URGENT MEDICAL DEVICE CORRECTION AND REMOVAL

Subject: PathFinder NXT Fixed Rod Holder Instruments

Affected Products: **PathFinder NXT Fixed Rod Holder Instruments Part numbers 3573-1 (angle handle) and 3573-2 (straight handle); All lots.**

Figure 1

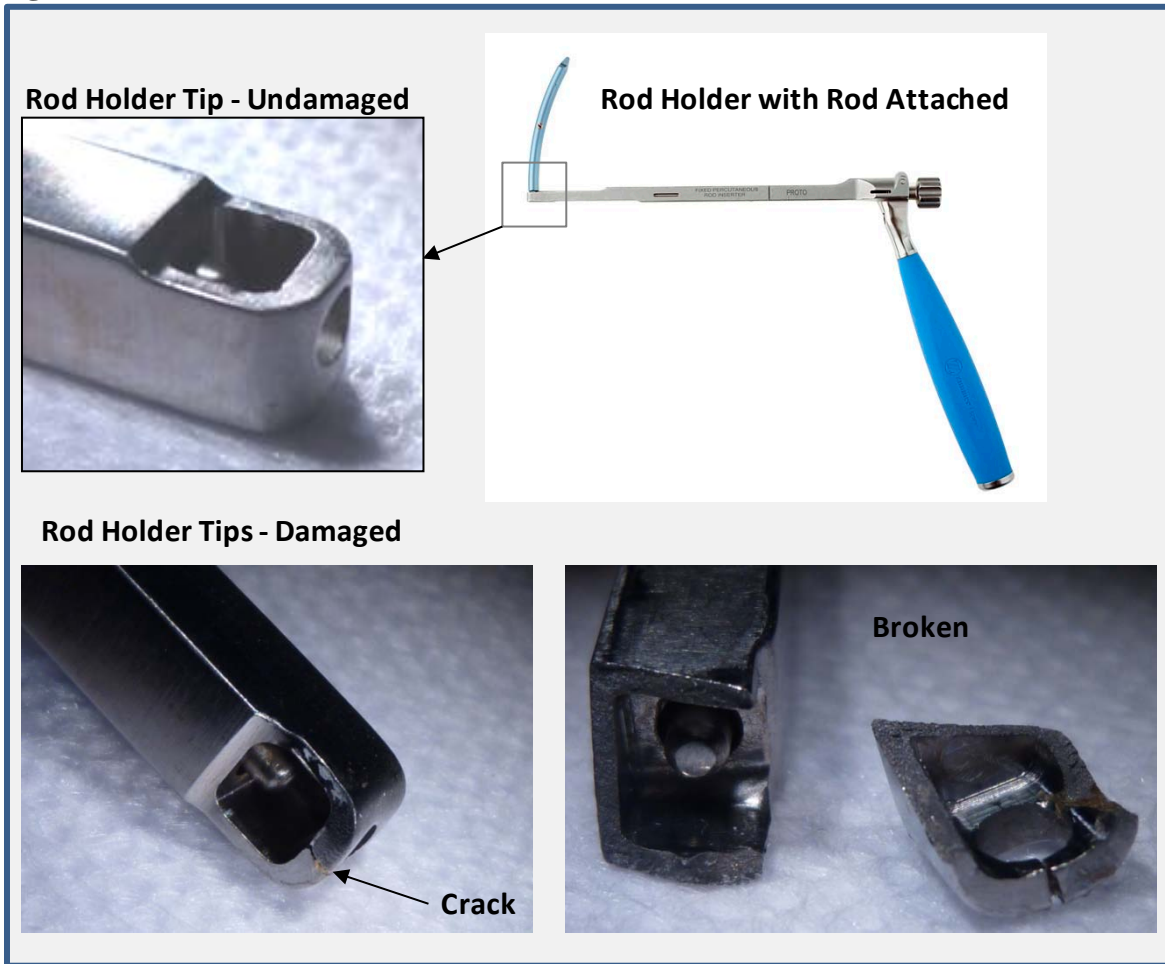
<u>Step</u>	<u>Current IFU and Surgical Technique Guidance</u>	<u>Additional Guidance / Information to Reduce Rod Holder Tip Damage</u>	
PRIOR TO PROCEDURE	Inspect instrument for damage If damage or wear is noted that may compromise proper function, do not use	See Figure 1 for example of crack that may lead to breakage	If damage to the rod holder tip is found before or during use, Fixed Grip 5.5mm Rod Holder (part number 3562-1) may be utilized with a mini open technique
ROD PLACEMENT	Turn set screw knob until it seats fully on the percutaneous rod	The rod is fully seated when the knob is finger tight	
CLOSURE TOPS PLACEMENT	N/A	When inserting closure tops, ensure that the extender sleeves and rod holder are not touching/wedging together and creating a lever effect on the distal end of the rod holder	
ROD HOLDER REMOVAL	Disengage the rod from the rod holder by rotating the knob counterclockwise until stopped Translate the rod holder away from the construct and remove from the incision	The knob should be fully loosened prior to removal Translate the distal tip away from the rod/screw construct Do not rock the holder excessively to disengage from the rod

POST USE	N/A	Inspect the rod holder tip for damage after each use. See Figure 1 If damaged, remove from service

Figure 1

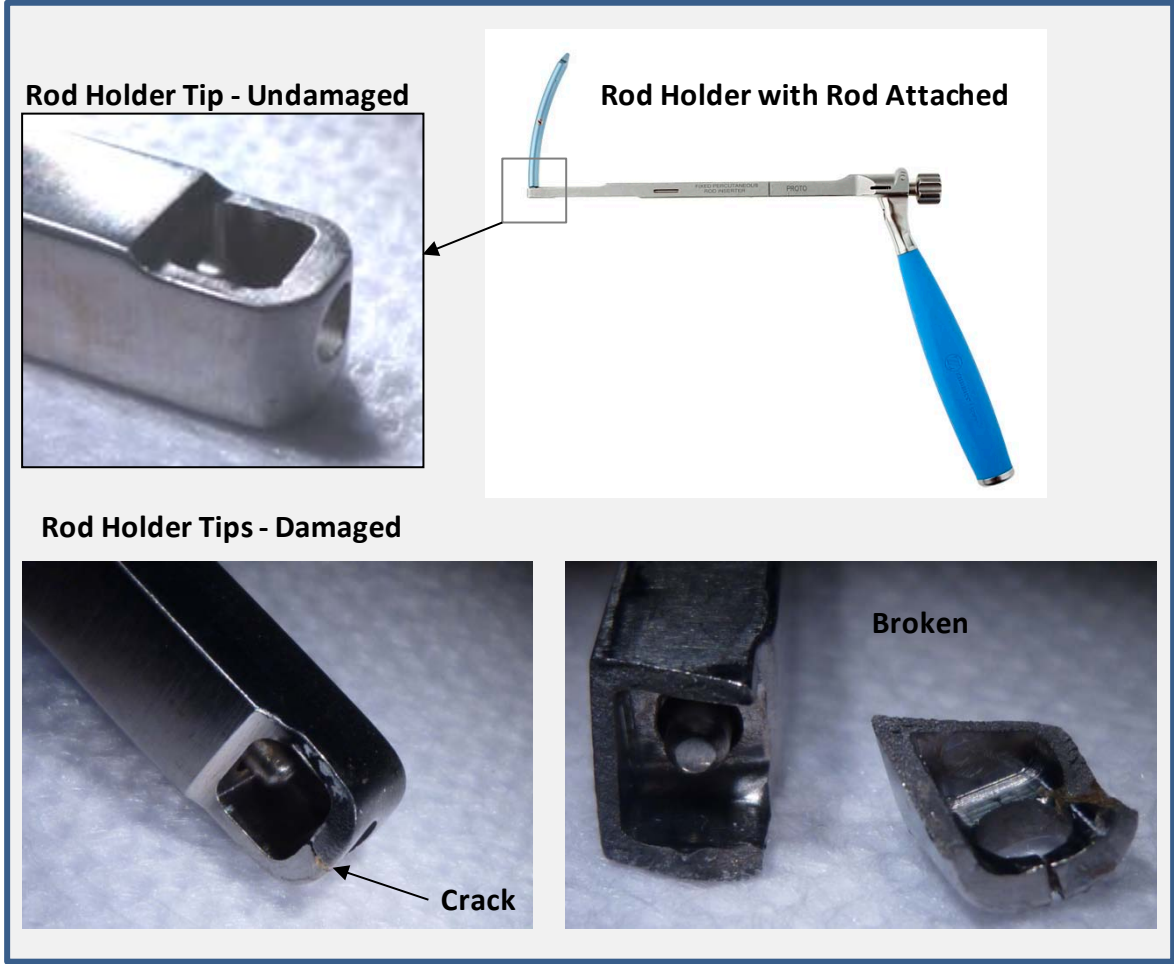
<u>Step</u>	<u>Current IFU and Surgical Technique Guidance</u>	<u>Additional Guidance / Information to Reduce Rod Holder Tip Damage</u>	
PRIOR TO PROCEDURE	<p>Inspect instrument for damage</p> <p>If damage or wear is noted that may compromise proper function, do not use</p>	See Figure 1 for example of crack that may lead to breakage	
ROD PLACEMENT	Turn set screw knob until it seats fully on the percutaneous rod	The rod is fully seated when the knob is finger tight	If damage to the rod holder tip is found before or during use, Fixed Grip 5.5mm Rod Holder (part number 3562-1) may be utilized with a mini open technique
CLOSURE TOPS PLACEMENT	N/A	When inserting closure tops, ensure that the extender sleeves and rod holder are not touching/wedging together and creating a lever effect on the distal end of the rod holder	
ROD HOLDER REMOVAL	<p>Disengage the rod from the rod holder by rotating the knob counterclockwise until stopped</p> <p>Translate the rod holder away from the construct and remove from the incision</p>	<p>The knob should be fully loosened prior to removal</p> <p>Translate the distal tip away from the rod/screw construct</p> <p>Do not rock the holder excessively to disengage from the rod</p>

POST USE	N/A	<p>Inspect the rod holder tip for damage after each use. See Figure 1</p> <p>If damaged, remove from service</p>
